Re: **Summerside West Phase 4-6
City Comment Response Memo**

This memo has been prepared to address comments received from the City of Ottawa on January 31, 2018, for the Summerside West Phases 4-6 plan of subdivision submission. The following comments have been noted to the proponent and responses by Parsons can be found herein.

The East Urban Expansion Area EA preferred option is illustrated below.

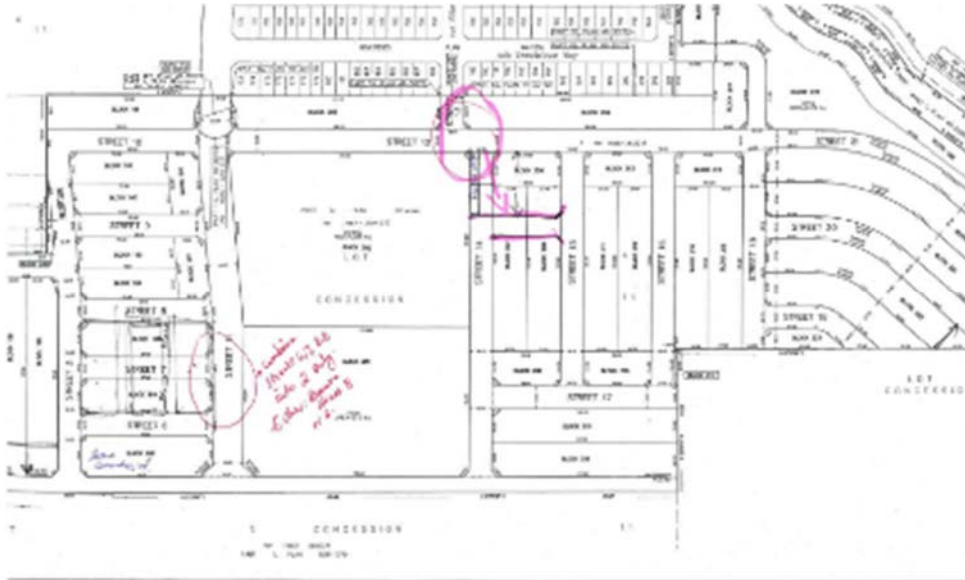
Comment 16: *The intersection of Street 1 at Street 11 be shown on the plan. There is an opportunity to construct a mini roundabout at this location.*

Response 16: The East Urban Expansion Area EA, completed in July 2017, illustrates Street 1 and Street 11 as a roundabout, and the site plan illustrates a 24m radius preserved for the implementation of the intersection. At this stage, the intersection can be a mini-roundabout or a typical roundabout. There may be a preference on the City's, and Emergency Services, to implement a typical roundabout over a mini-roundabout at a collector-to-collector road intersection.
